Dennis Jackson - Hydrologist

October 22, 2007

Re: File No. UPE04-0040, Gualala Instream Gravel Mining, Gualala Redwoods

Project Description

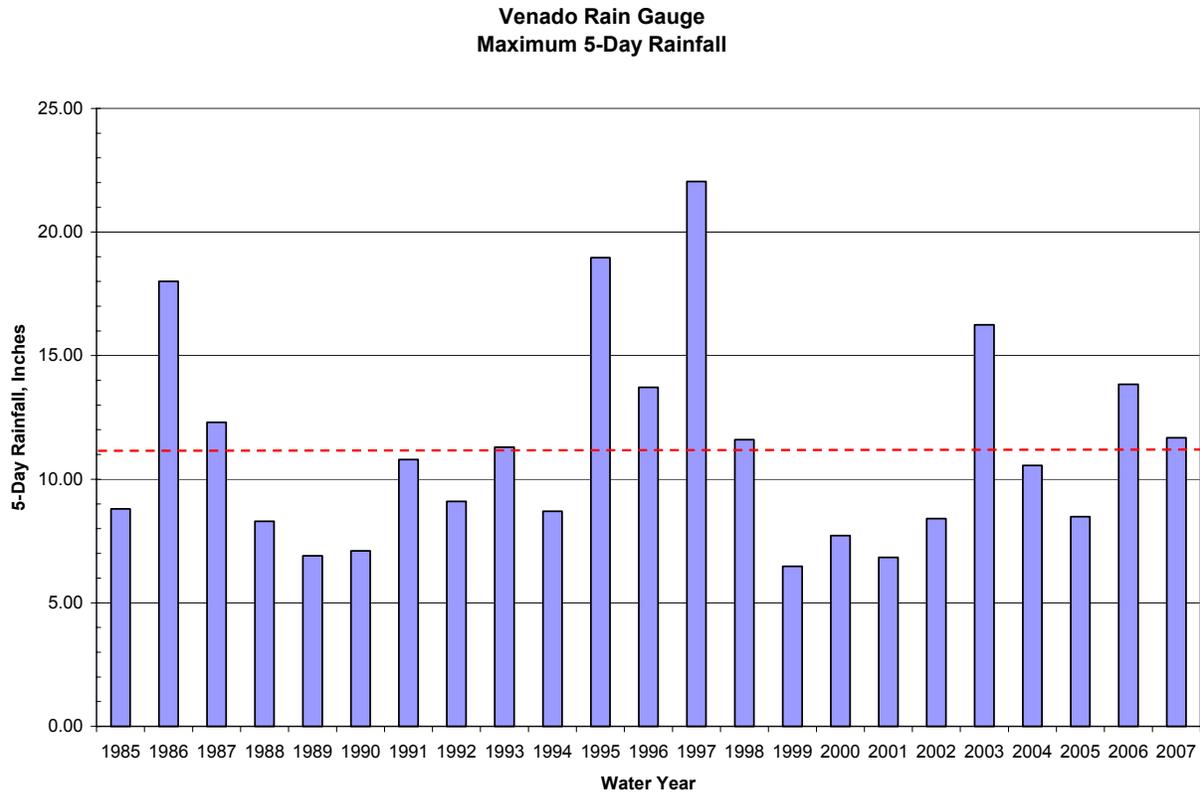
The MND discusses the scenario where a summer freshet flows over the gravel bars and is warmed. The MND fails to discuss the potential for gravel extraction to cause the low-flow channel, either at the extraction site or downstream, to shift and go down the center of a gravel bar. If the low-flow

The cumulative effect of the continuous gravel mining since the 1960's prevented the South Fork of the Gualala River from adjusting its width, depth and gradient to carry the sediment supplied to it by the watershed. If the continuous gravel mining had not removed about 1,139,000 cubic yards it is likely that the active channel may have narrowed. The narrower active channel would have provided more shade to the low flow channel and the water temperature would presumably have been cooler. The MND does not examine this cumulative impact.
